APPEAL SUMMARY

Appeal ID: 27508

Project Address: 1656 SW Sunset Blvd

Appeal Type: Plumbing

PARTITION PLAN

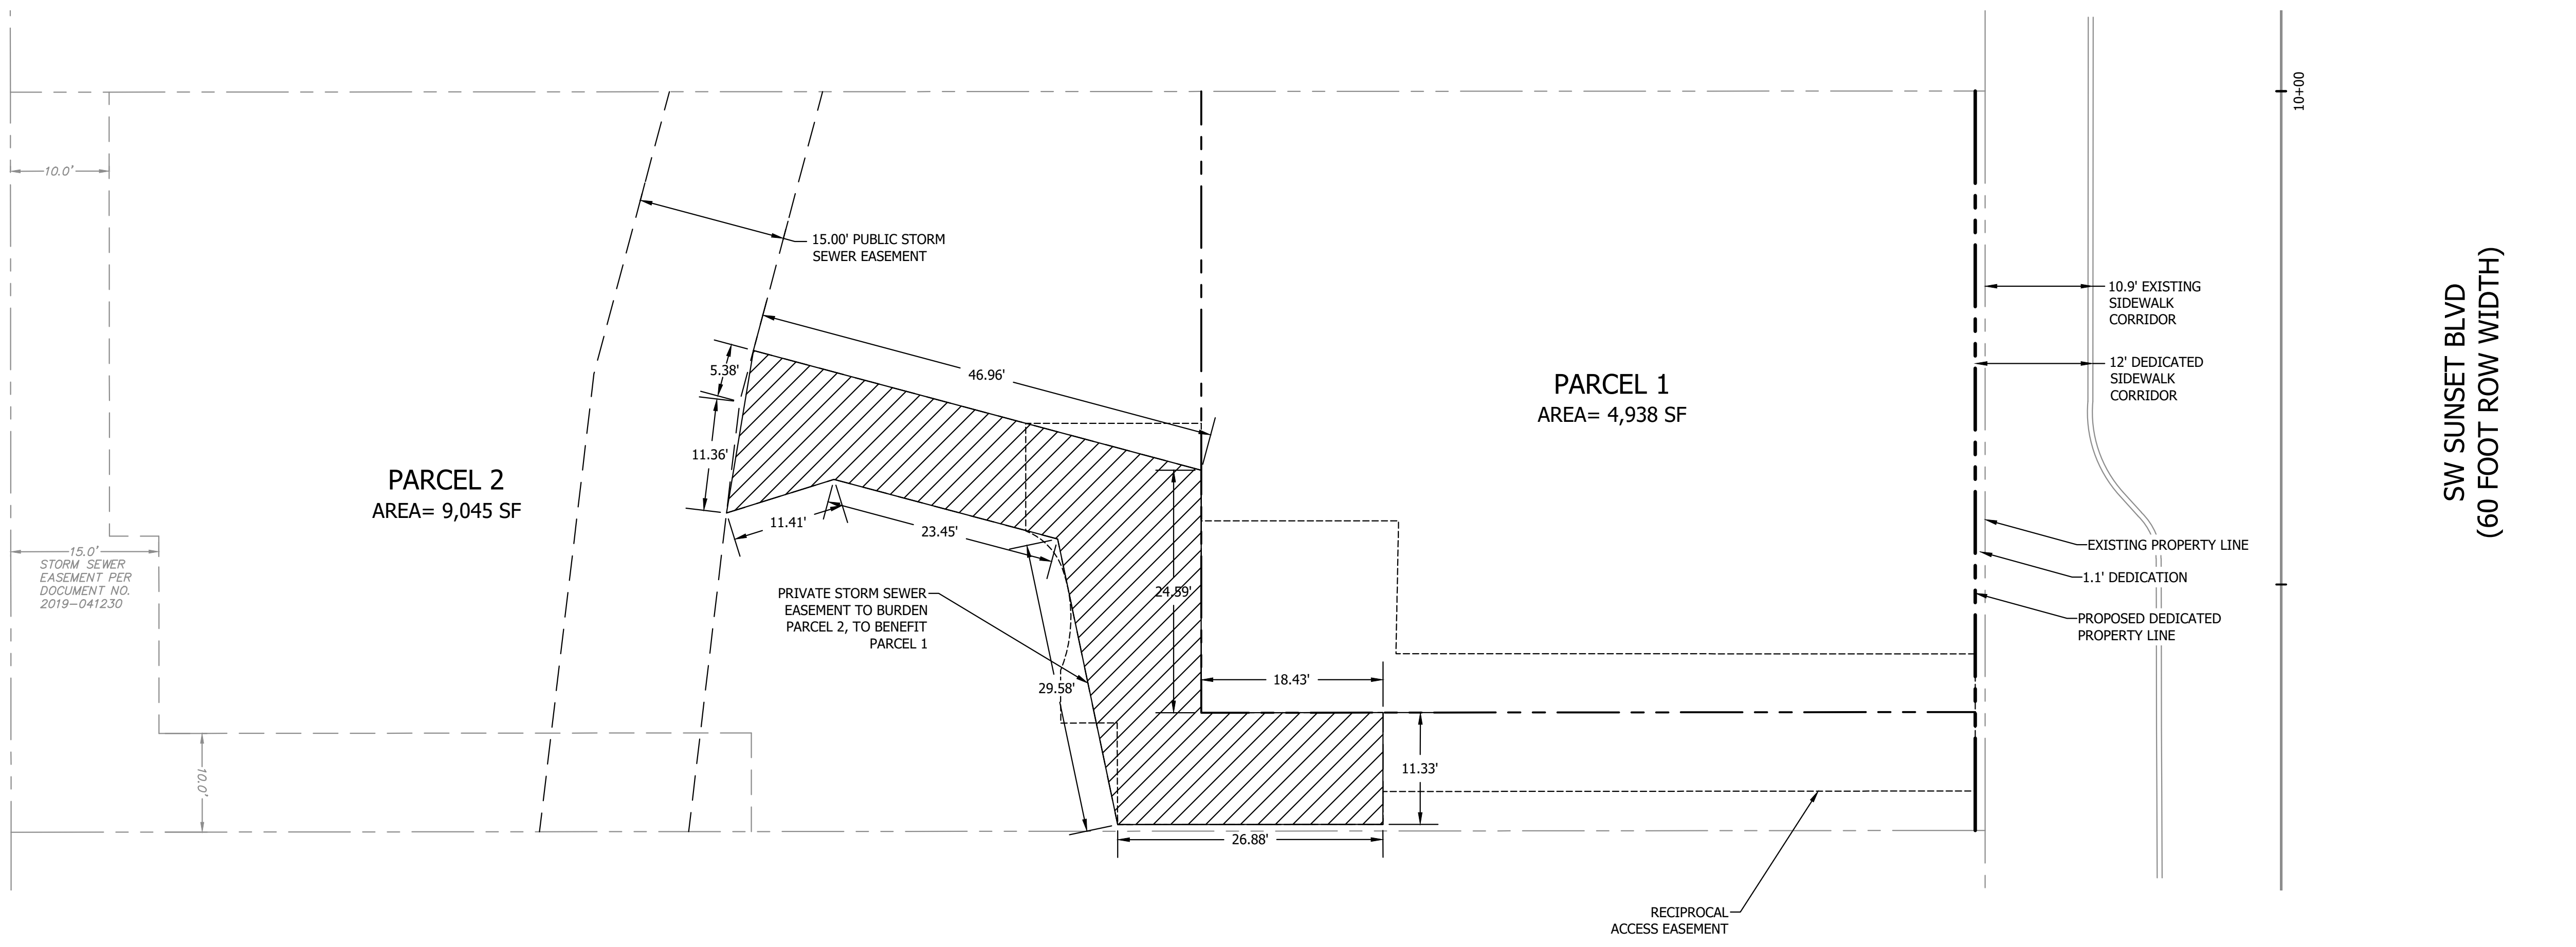
Construct a 14" trench drain at the bottom of a sloped driveway. 6' of the drain will be on parcel 1. 8' of the drain will be on parcel 2. The trench drain will be connected to the private storm system of parcel 2 with storm water treated in a flow through planter on parcel 2. There will be a BES approved private covenant or easement to address maintenance and upkeep.

Attachment 1 shows detail of the proposed trench drain with dimensions on either side of the lot line.

Attachment 2 shows the proposed utility plan, including the shared sewer line and the flow through planter.

Attachment 3 provides detail of the proposed easement with full dimensions. (The final, legal description of the easement will be part of the final plat submitted after land use decision has been issued and conditions have been met.)

Construction of a continuous trench drain across a lot line for stormwater collection with access easement and maintenance agreement: Hold for additional information.
